SOLACE AT CIMARRON HILLS
 SITUATED IN THE NORTHWEST QUARTER OF SECTION 7
 TOWNSHIP 14 SOUTH, RANG 65 WEST OF THE SIXTH PRINCIPAL MERIDIAN
 COUNTY OF EL PASO, STATE OF COLORADO
WATER DISTRIBUTION PLAN

SOLACE AT CIMARRON HILLS
WATER DISTRIBUTION PLAN

SANITARY SEWER PLAN AND PROFILE

**WL-8 PROFILE
STA 0+00.00 TO 7+65.00**

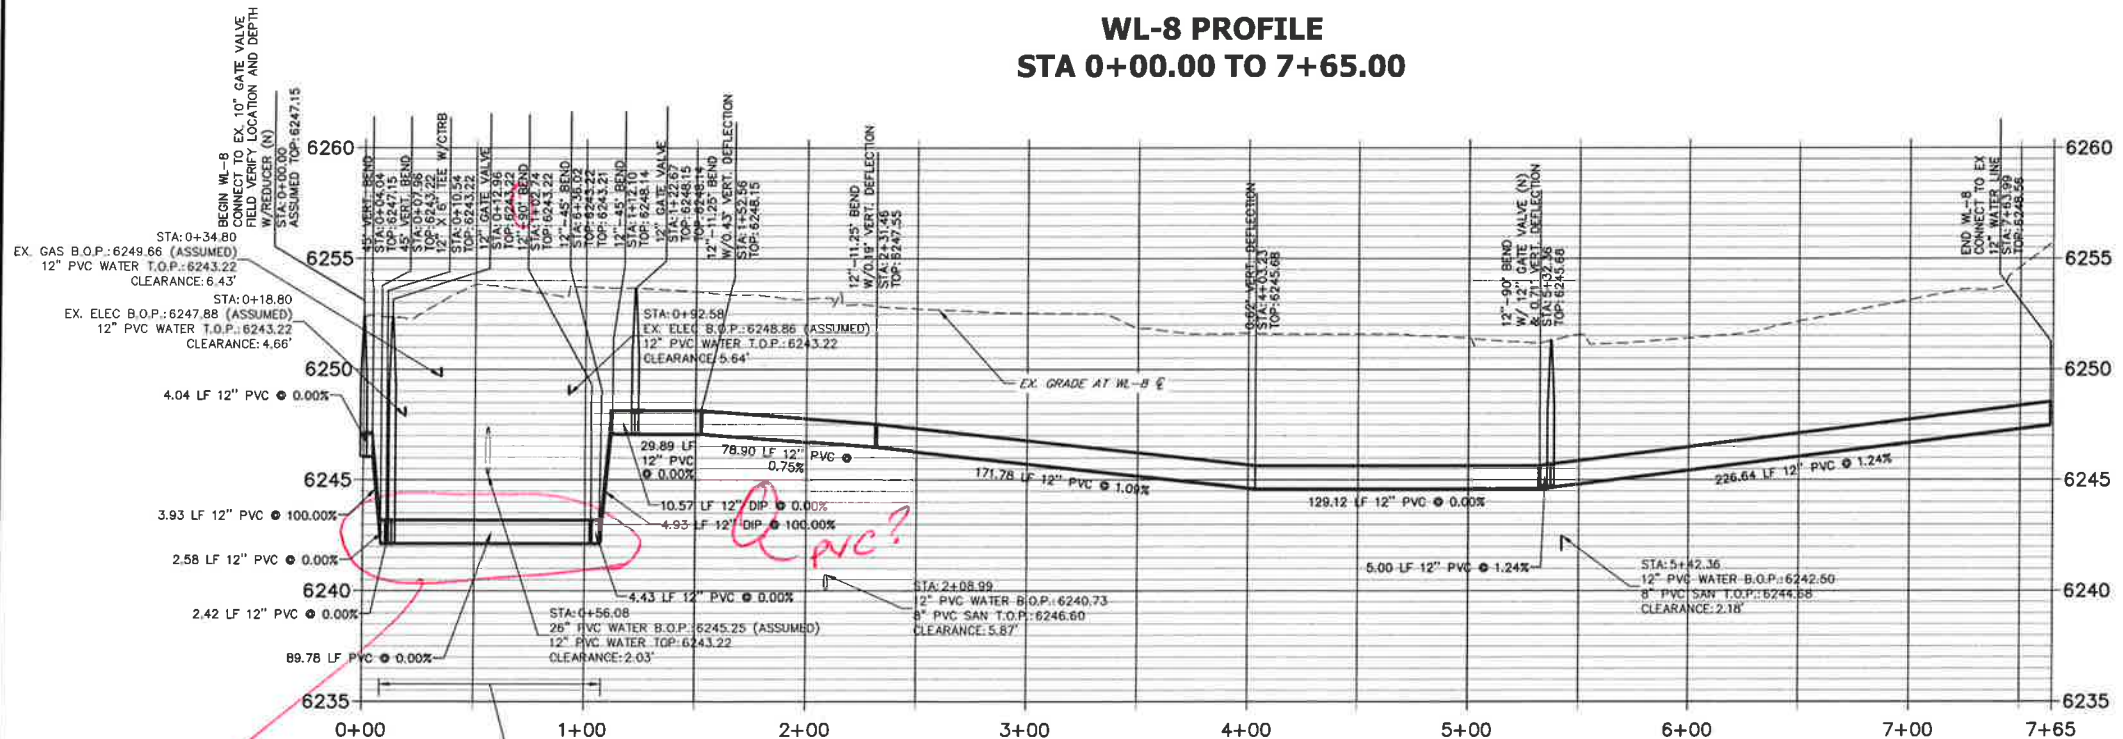
*don't combine 90° H w/ 45° Vert.
Lowering only req'd to extend 9' past CSU pipe*

SHEET 7 OF 12
 JOB NO. 25174.00

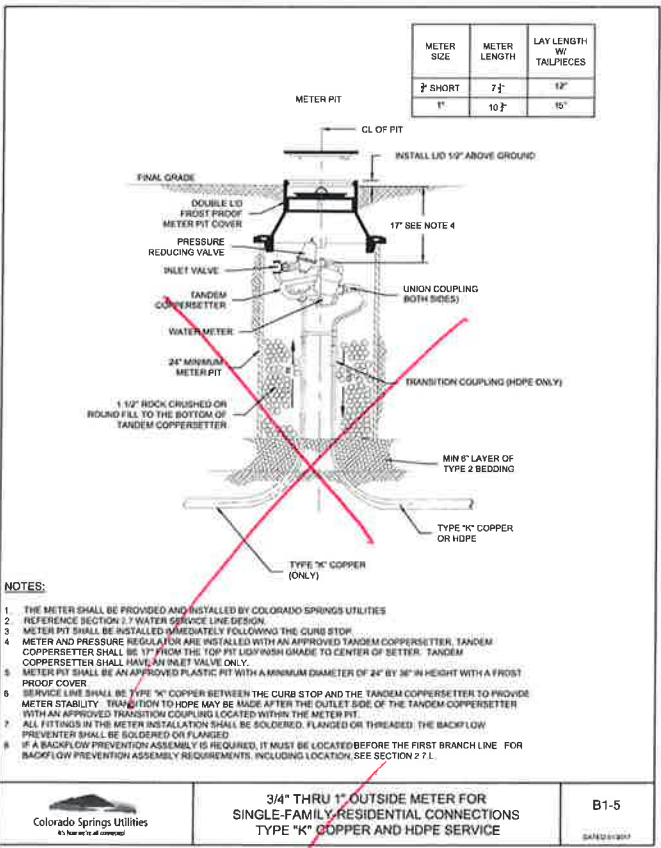
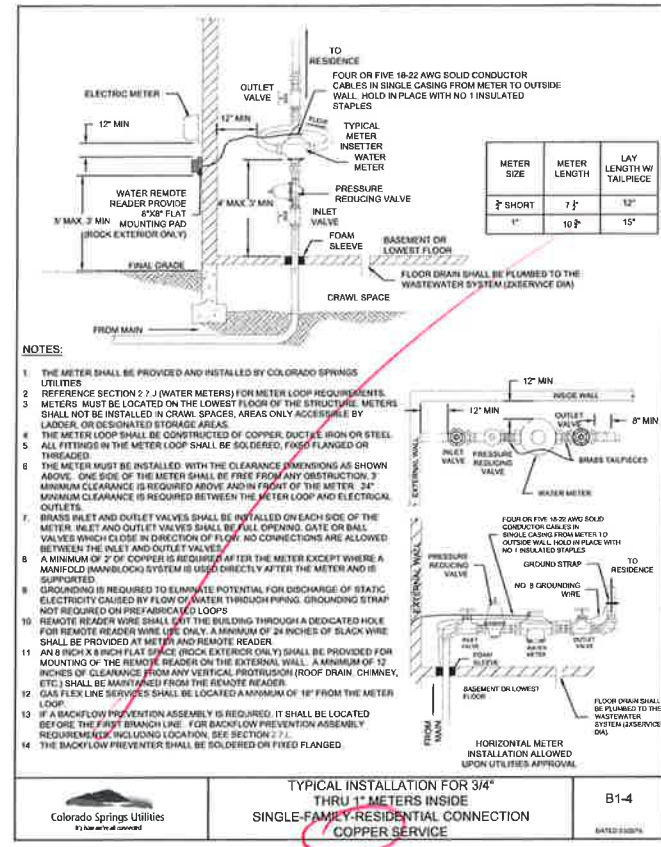
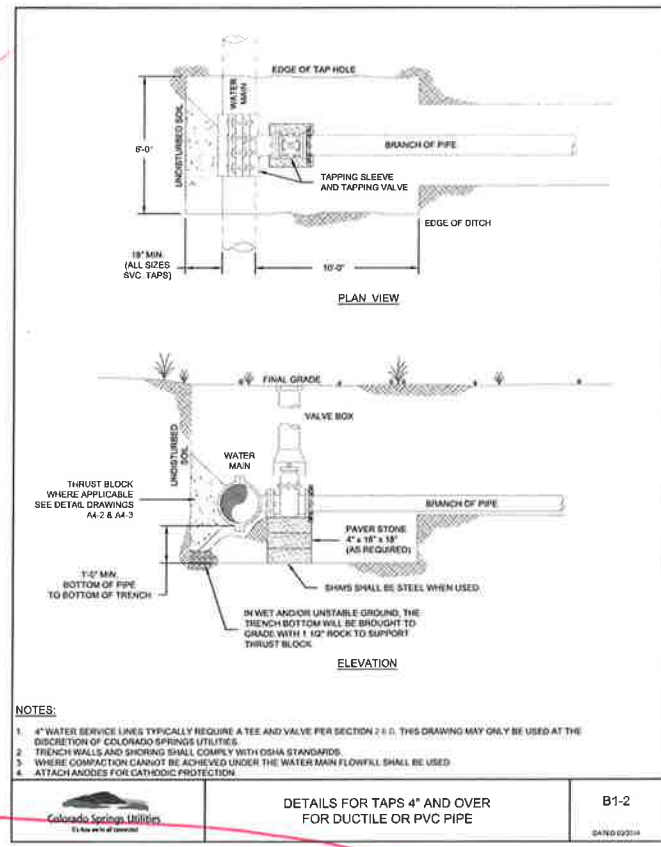
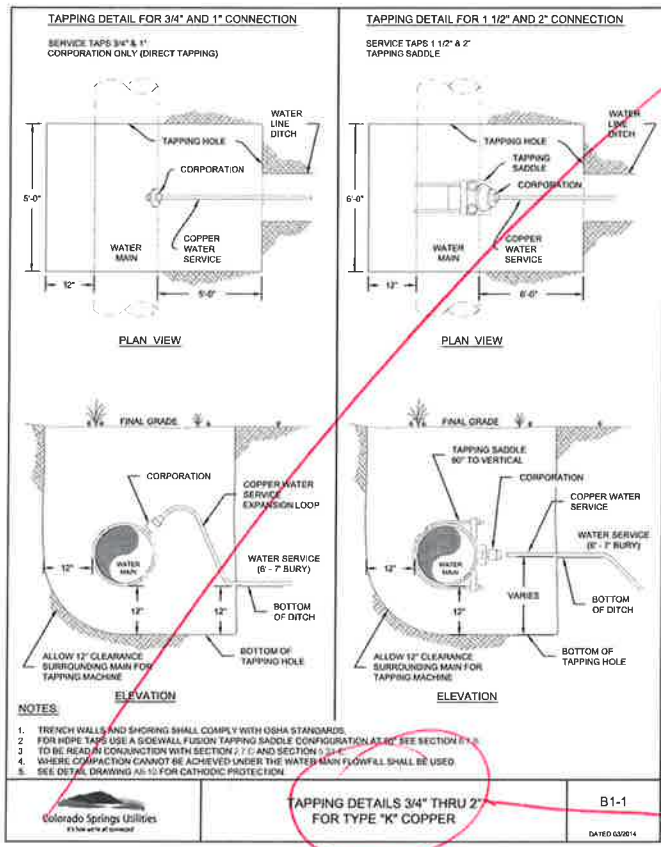
*COPPER NOT ALLOWED
USE B1-6 & CMD STD B1-11A (ON STREET 9 OR 12)*

LOCATE METERS INSIDE BLDG. MECH ROOM

SHEET 8 OF 12
JOB NO. 25174.00

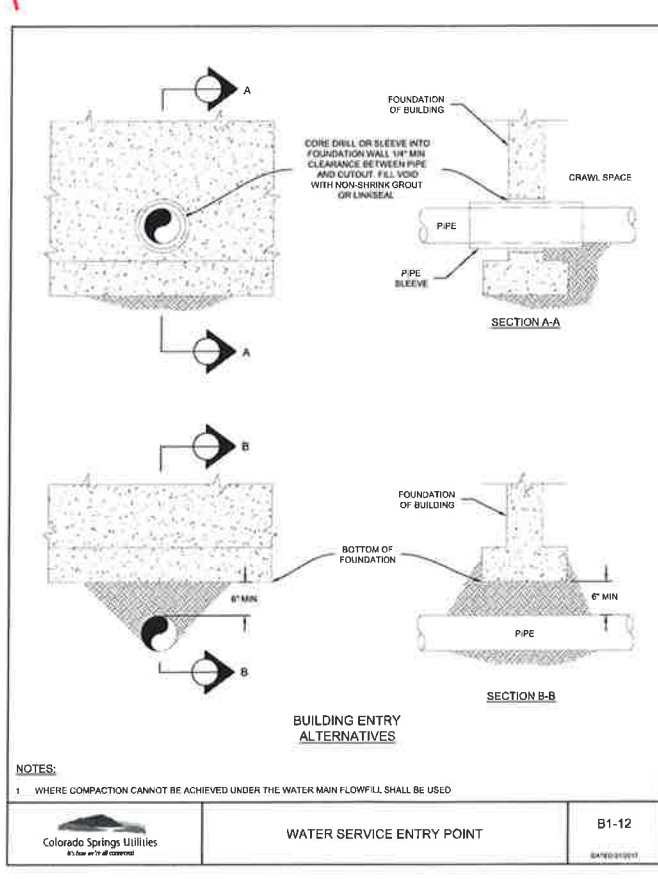
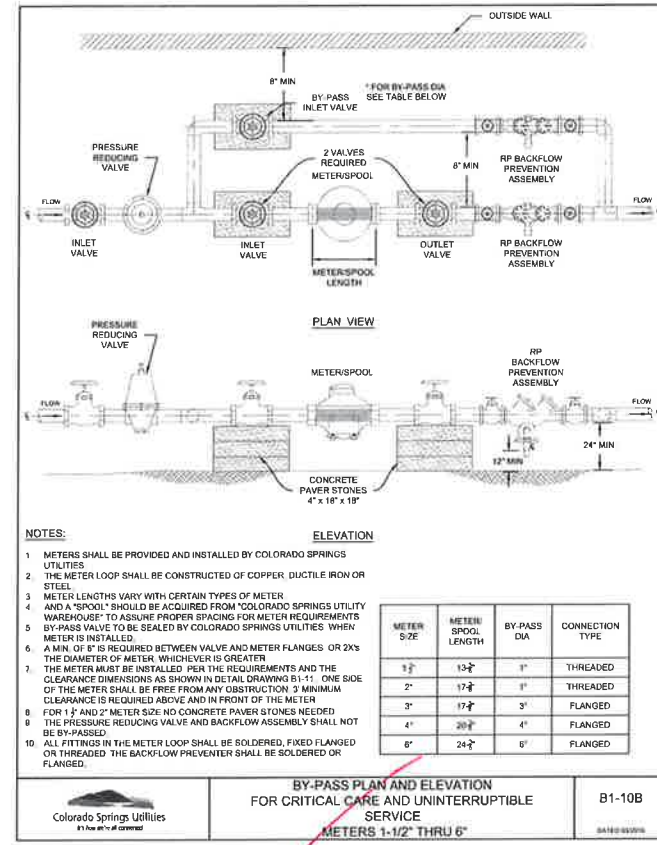
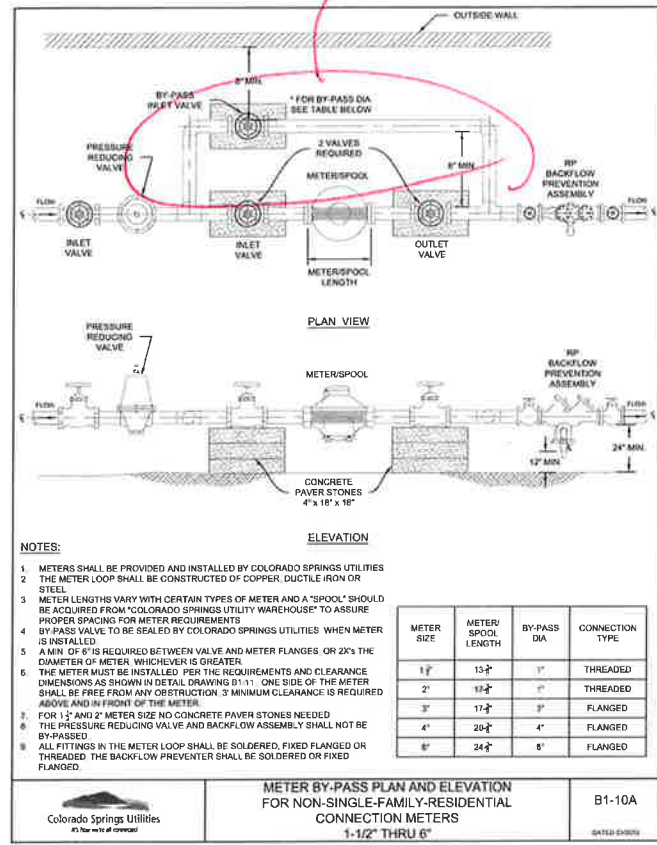
BY PASS NOT ALLOWED

ADD DETAIL FOR COMMERCIAL METER W/ BACK FLOW POOL BUILDINGS

NO BY PASS
